473 Albert Street Site Plan Control Application

Addendum - Planning Rationale and Urban Design Brief

Figure 1: Proposed Front Entrance

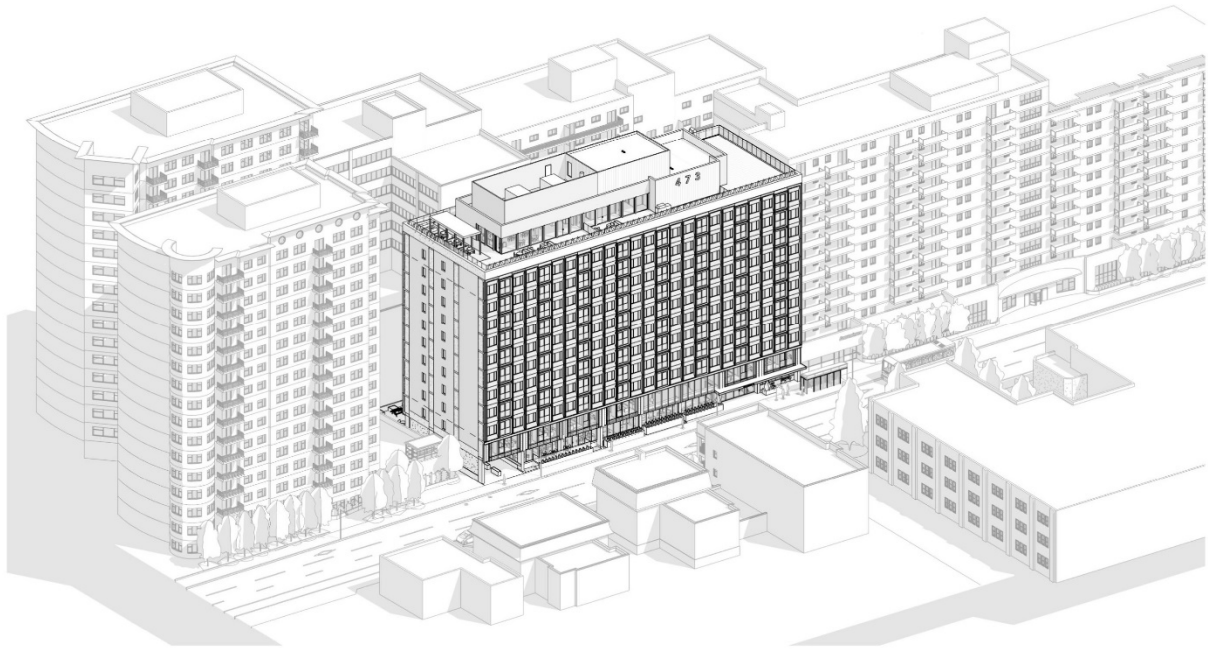
- 158 residential units (5 additional units),
- On average larger units and work from home station included where possible,
- 52 parking spaces of which 10 will be allotted to visitor parking,
- 86 total bicycle parking spaces (68 horizontal and 18 vertical spaces),
- The removal of all commercial and office space,
- The rooftop will house both the amenity and the mechanical penthouse on the same level,
- Increased amenity space and relocating some of it internally (creating a business centre, larger gym space on ground floor),
- Retaining the original core of the existing building,
- Relocation of front entrance to the right side of the building.

Figure 2: Site Plan of 473 Albert Street

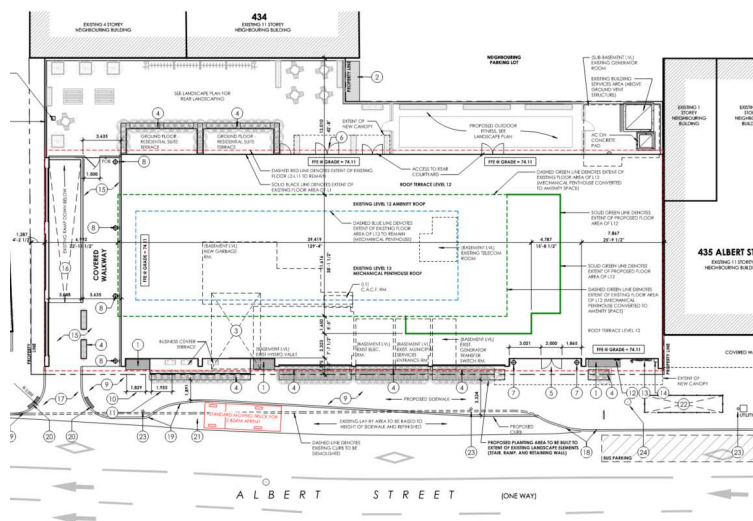
The revised proposal is still for the adaptive re-use of the existing 11-storey building. The conversion now consists of a slight increase in residential units, the removal of the commercial and office space and modifications to the amenity and landscaped areas. The changes made are a result of City comments and market research of the neighbourhood. The key revisions to the proposal are:

Figure 4: South Elevation fronting onto Albert Street

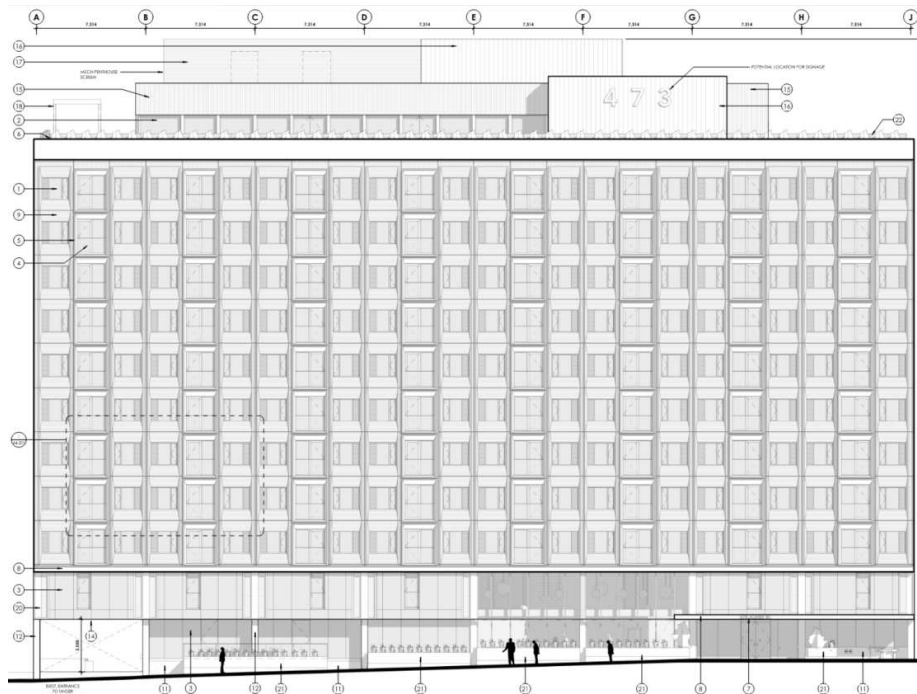
Since the proposal is utilizing the existing building, no changes to the building transition or massing are proposed. The building envelope will remain largely untouched, except for the redistribution of juliet balconies on the south and west elevations to create more symmetry. All windows throughout the building will be replaced.
